NUCLEAR
PACKAGING, INC.

PDR
71-9097

REFERENCE: Docket Number 71-9097

SUBJECT: Certificate of Compliance for CNSI Cask 14-195L

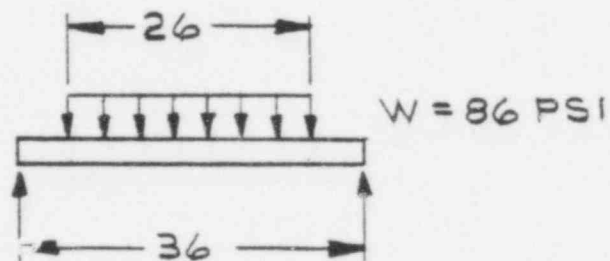
Question No. 2

Both the primary and secondary lid of the cask have been structurally revised. Please note changes shown in Dwg. 1-295-100, Rev. H.

Should the cask impact onto the primary lid end of the cask, loads would be reacted across a number of contact points.

From the drawing it can be seen that a heavy 7/8 inch thick steel plate has been added to the secondary lid to bring its surface up to and flush with the outer cask rim. Therefore, the secondary lid will react inertial and payload impact forces in direct compression.

Loads across the primary lid will be reacted at the outer rim by the 12 spacer block (i.e., Item 15). In addition, eight

heavy gauge square tubes have been added to the lid to form radial spokes. These tubes are also flush with the top surface of the cask and will provide uniform support. Therefore, impact forces will be reacted in direct compression across the primary lid and spacers, thus resulting in little or no bending stresses.

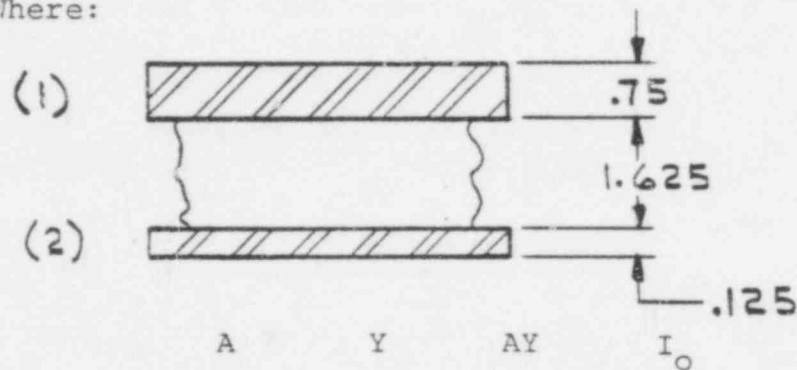
Question No. 3

As noted above, the secondary lid has been modified to include an additional 7/8 inch thick plate to the outside surface. This plate does not completely cover the central portion of the lid and is, therefore, conservatively neglected from the following analysis.

Loads across the secondary lid could result from inertial forces of the lid and payload. This load for the total primary lid was calculated to 400337 lbs. or 86 psi.

From Roark, 4th Edition, Case 2, the maximum stress is given as:

$$\begin{aligned} S &= (45660/4\pi 3) (6/t^2) \left[3+4 \log 18/13 - 2(13)^2/4(18)^2 \right] \\ &= 1211.6 (6/t^2) (4.04) \\ &= 4896 (6/t^2) \end{aligned}$$

$$S = 18247 \text{ psi}$$

$$\begin{aligned} \text{M.S.} &= F_{Ty}/S-1 \\ &= (36000 \text{ psi})/(18247 \text{ psi})-1 \\ &= \underline{+0.97} \end{aligned}$$
